Access Compliance Report

Public Rights-of-Way

(Curb Ramps)

Intersection ID: 44933	Main Street: ACORN_FOREST_LN	Cross Street: BRUMIT_LN	Location:	N
ADA ID: F892968A5BD4	Ramp Type: PerpDiag	Initial Pass/Fail: Fail	Overall Compliance: No	Severity Score: 33.75
Codes/Mitigation Info/Possible Solution		Field Measurements/Component Compliance

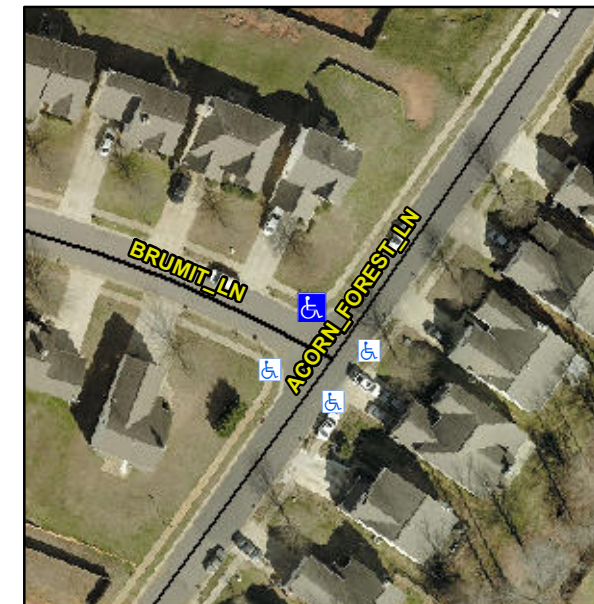
Not Found, R304.5.1, R304.5.3

Compliance	Description	Data	Compliance	Description	Data
N/A	Ramp Length (in)	48.0	Yes	Ramp Slope (%)	8.3
No	Ramp Width (in)	39.0	No	Ramp XSlope (%)	9.6
N/A	Flare Type LT	N/A	N/A	Flare Type RT	N/A
N/A	Flare Slope LT (%)	N/A	N/A	Flare Slope RT (%)	N/A
N/A	Flare Traversable LT?	N/A	N/A	Flare Traversable RT?	N/A
N/A	Landing Length (in)	N/A	N/A	DWS Provided?	N/A
N/A	Landing Width (in)	N/A	N/A	DWS Contrast?	N/A
N/A	Landing Slope (%)	N/A	N/A	DWS Length (in)	N/A
N/A	Landing X Slope (%)	N/A	N/A	DWS Full Width?	N/A
N/A	Landing Curb? (Y/N)	N/A	N/A	DWS Offset (in)	N/A
N/A	Shared Landing?	N/A			
N/A	Gutter Ponding?	N/A	N/A	Gutter Slope (%)	N/A
N/A	Gutter Lip Ht (in)	N/A	N/A	Gutter X Slope (%)	N/A
N/A	Painted X Walk1?	No	N/A	Painted X Walk2?	No
	X Walk 1 Direction	To SW		X Walk 2 Direction	To SE
N/A	X Walk 1 Width (in)	N/A	N/A	X Walk 2 Width (in)	N/A
	X Walk 1 Slope (%)	4.8		X Walk 2 Slope (%)	0.8
	X Walk 1 X Slope (%)	5.7		X Walk 2 X Slope (%)	7.4

N/A	Ramp inside XWalk1?	N/A	N/A	Ramp inside XWalk2?	N/A
	Road Slope (%)	6.9	N/A	Clear Space?	N/A
	Road X Slope (%)	4.3	N/A	Clear Space to XWalk (in)	N/A
N/A	Any Obstructions?	N/A	N/A	Storm Grate/Utility Hazard?	N/A
	Obstruction Type			Storm Grate/Utility Type	
		N/A			N/A
			Yes	Surface Condition? (G/P)	Good

Remove & Replace Curb Ramp With Two New Directional Ramps or Equivalent.
